STORM WATER MANAGEMENT DESIGN INTENT

FAIRFIELD
RESIDENTIAL

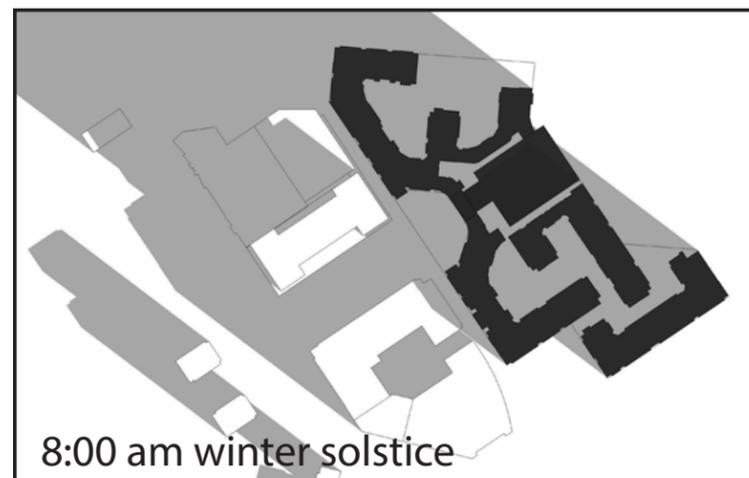
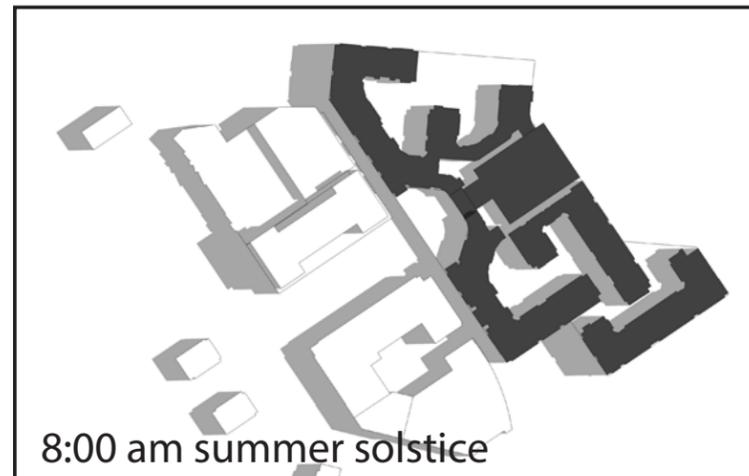
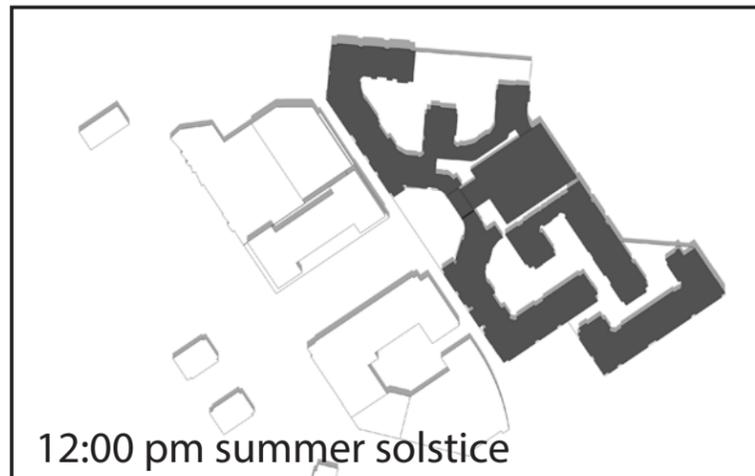
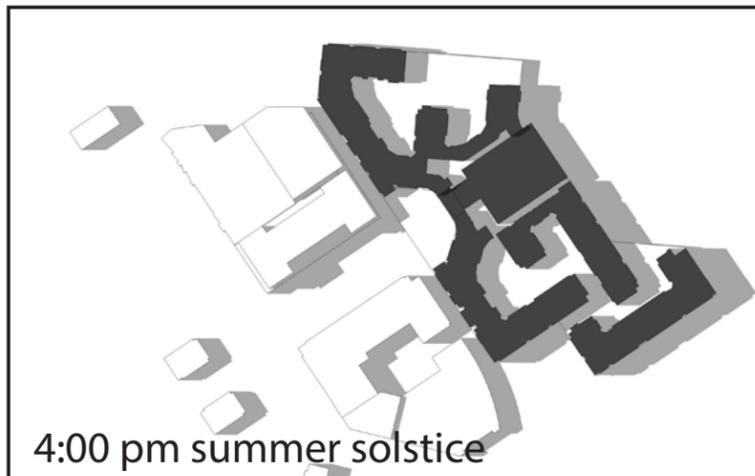
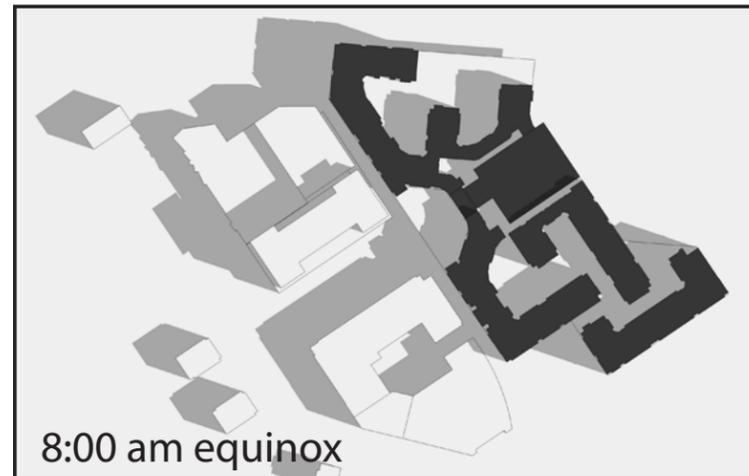
How will storm water be handled in the project? What type of planting will be proposed at the courtyards? Will there be mostly above grade planters?

OPTION A

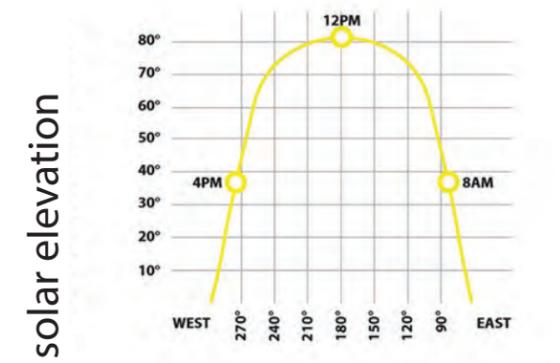
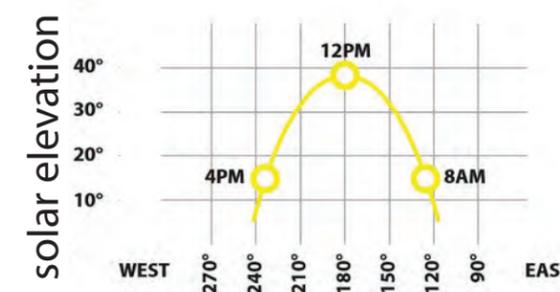
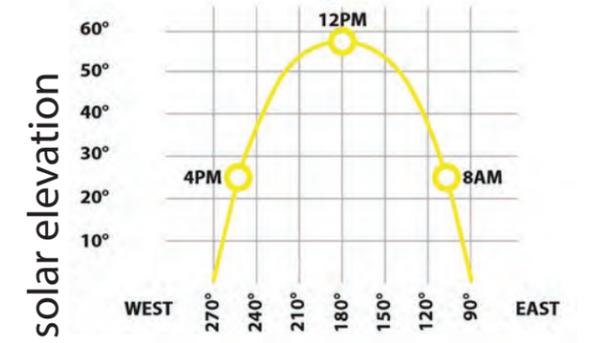
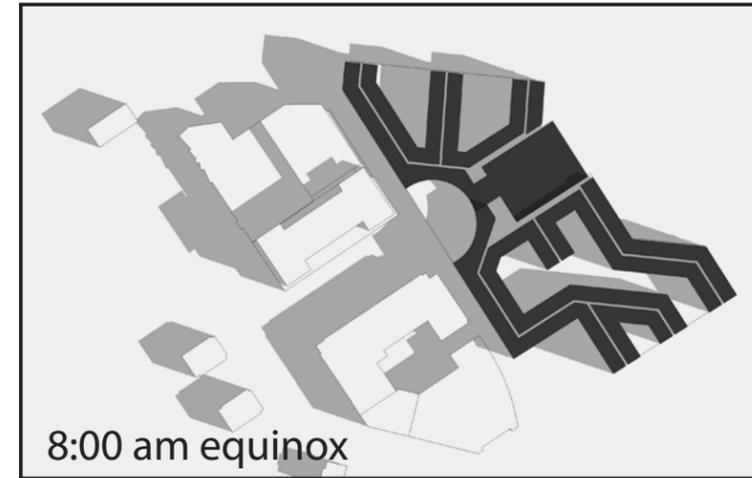
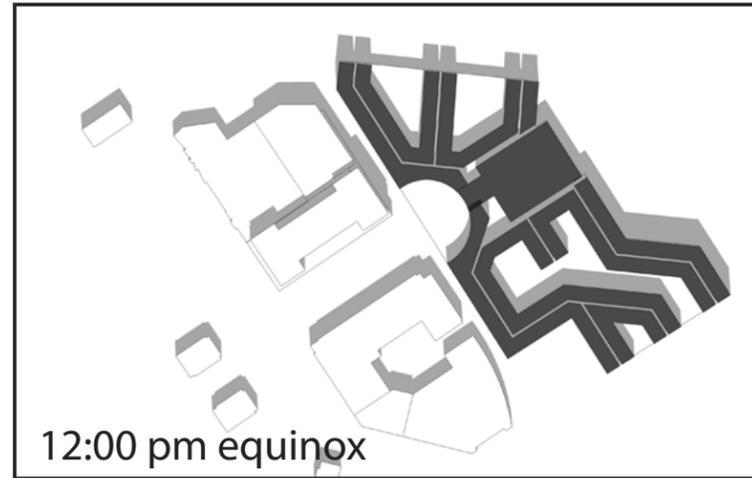
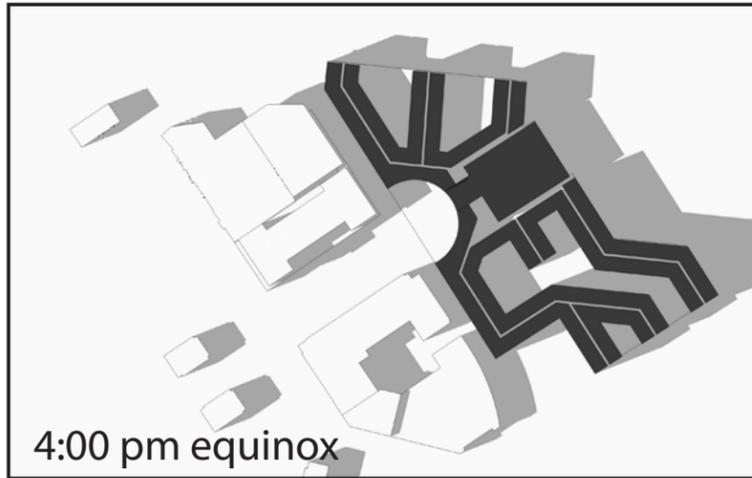
Provide shadow studies of options presented in Conceptual Design Conference

Shadow Studies for Option A provided.

OPTION B

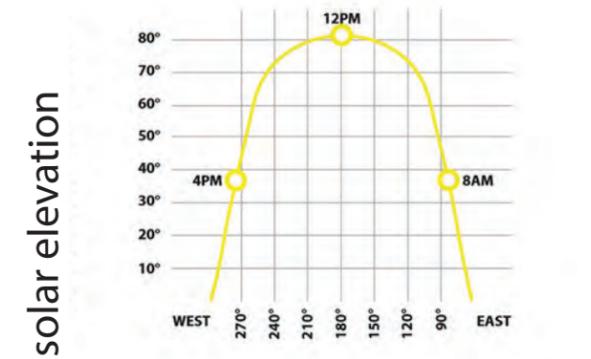
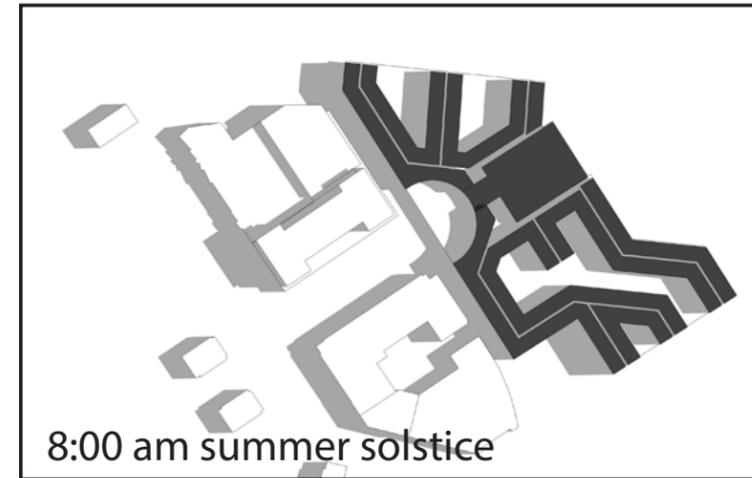
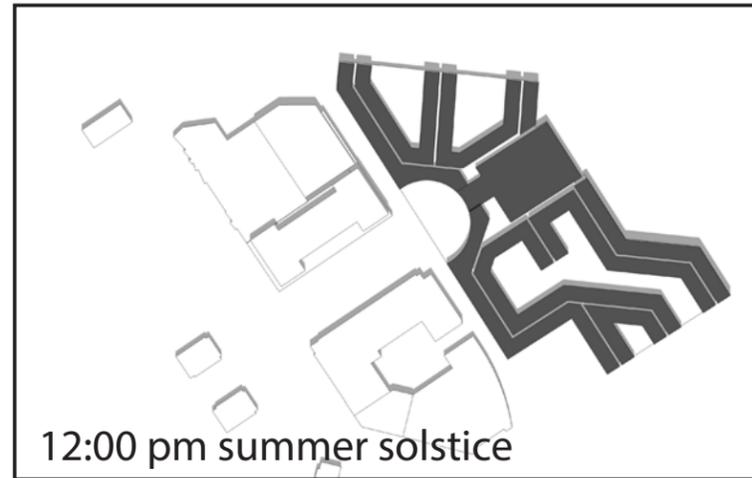
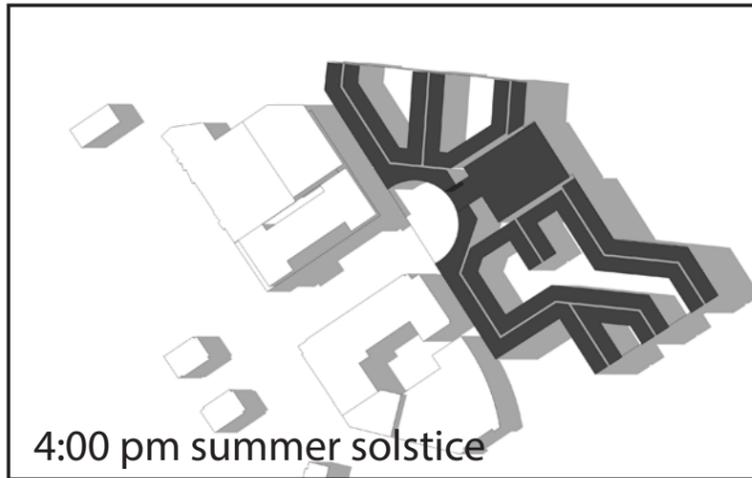
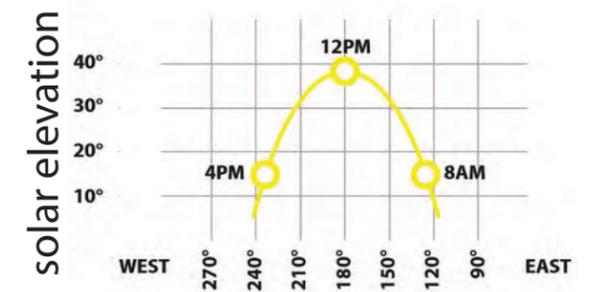
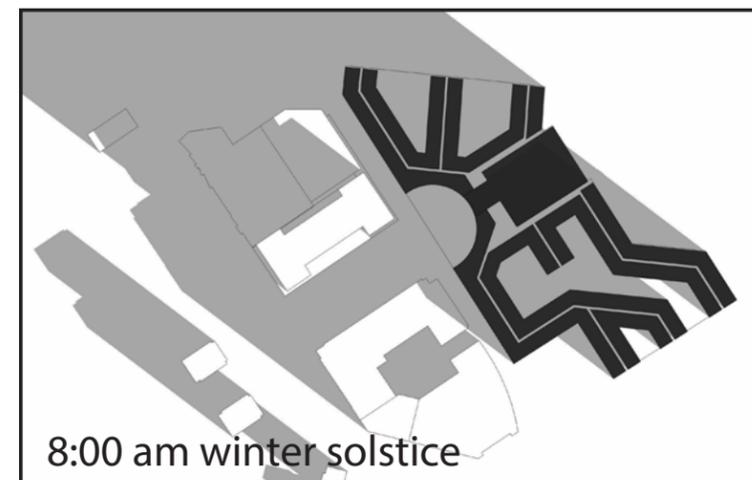
Provide shadow studies of options presented in Conceptual Design Conference

Shadow Studies for Option B provided.

OPTION C

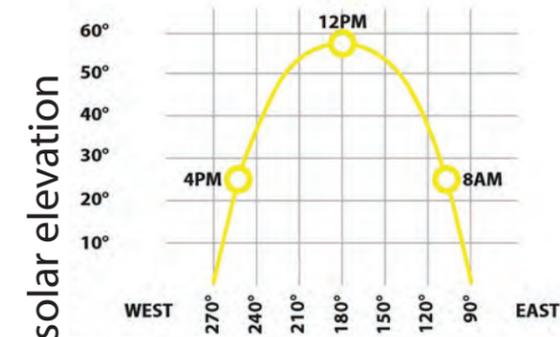
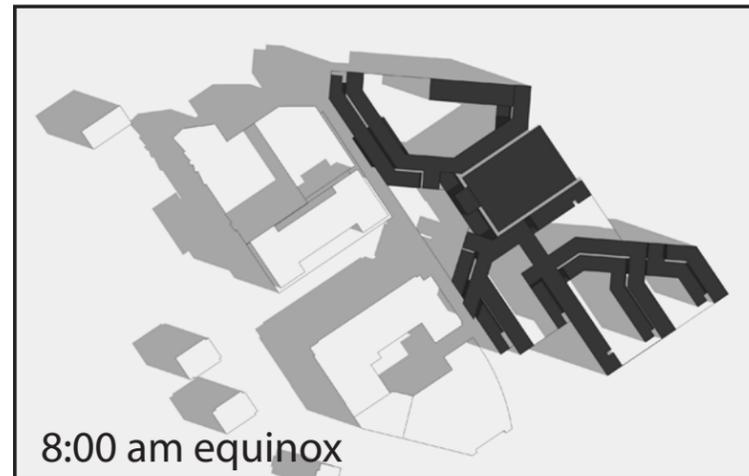
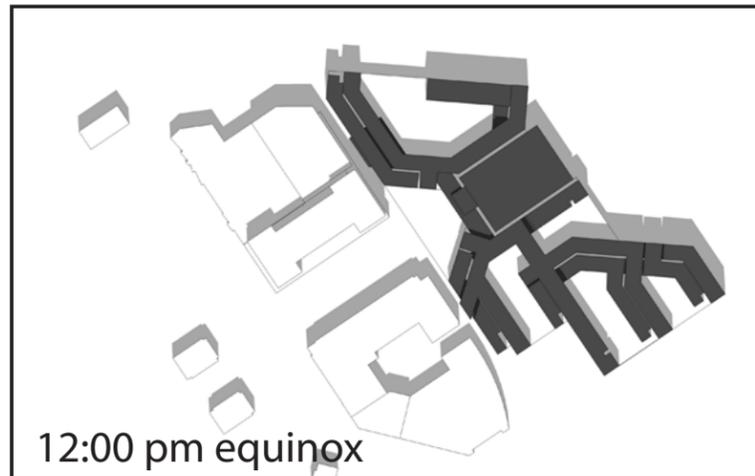
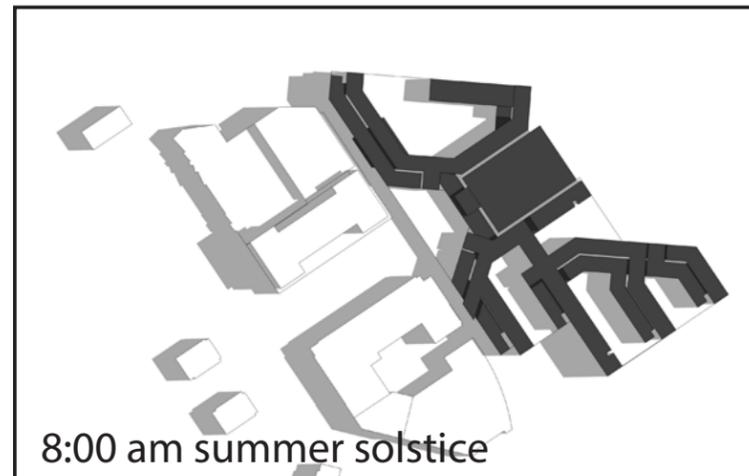
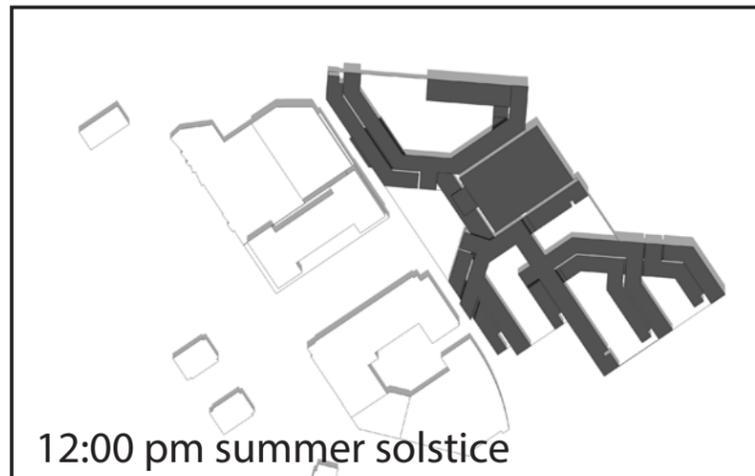
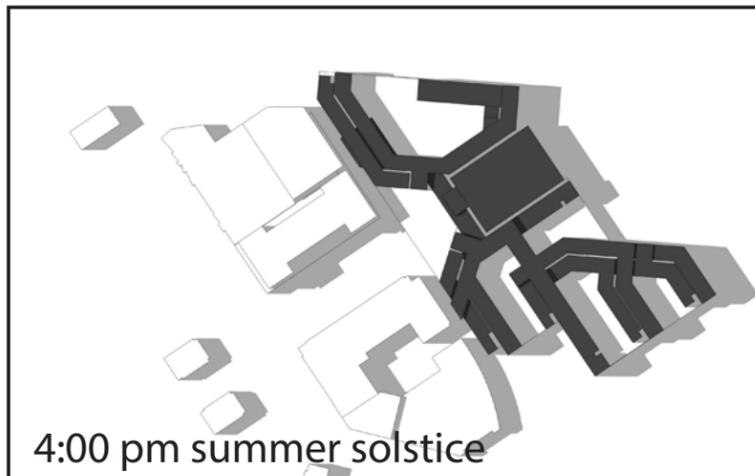
Provide shadow studies of options presented in Conceptual Design Conference

Shadow Studies for Option C provided.

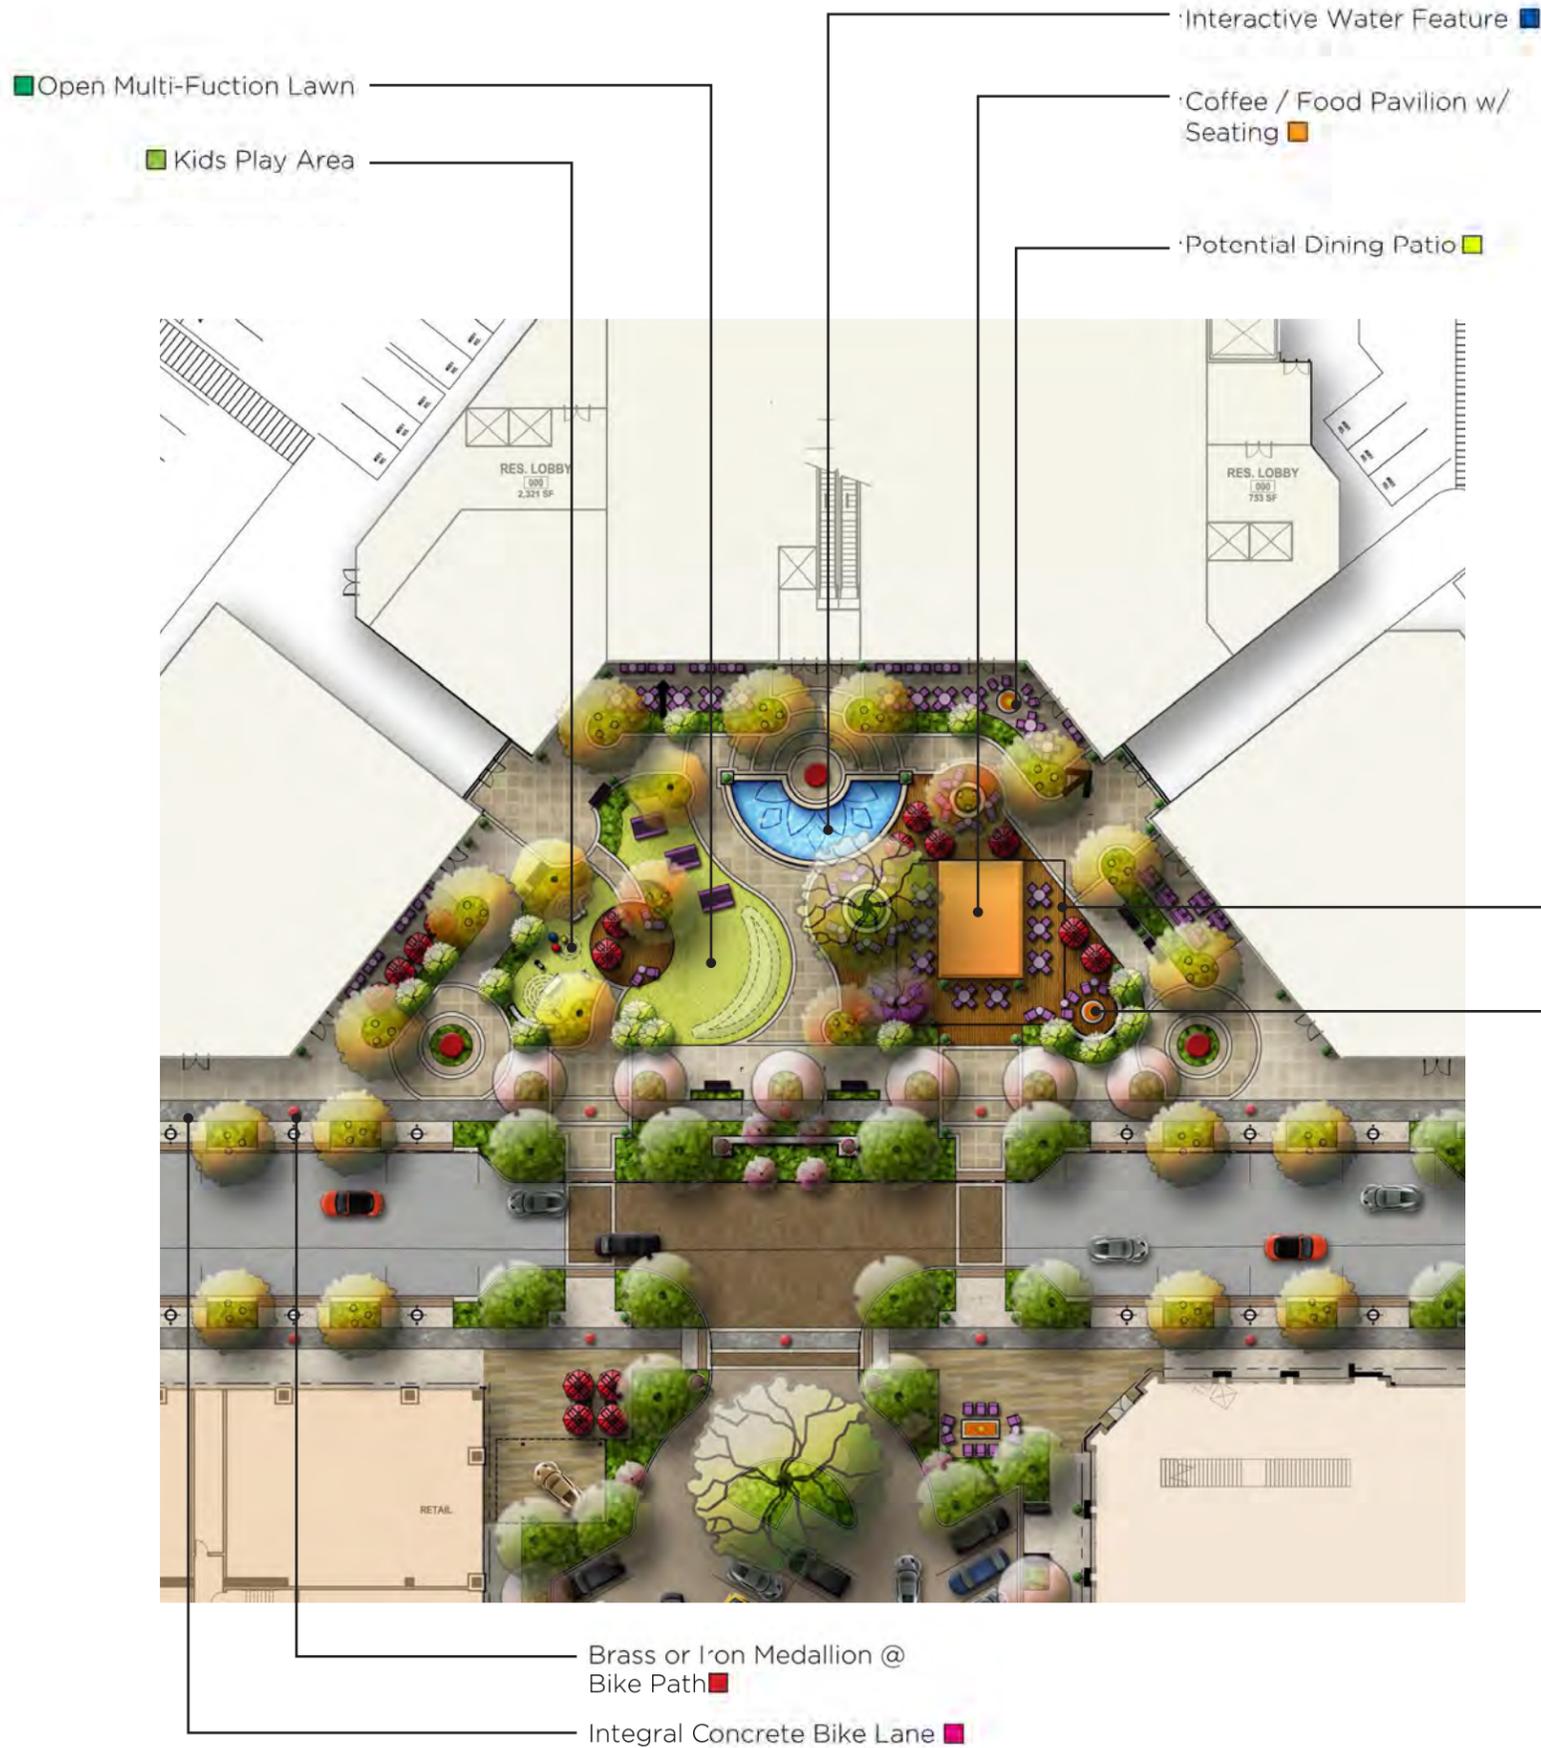
Concerned about the scale of the residential courtyards and the series of un programmed spaces.

All courtyards have been programmed to provide different activities for the residents and on the façade facing Totem Lake Way exterior staircases are shown leading from the courtyards directly down to the street to provide additional connectivity.
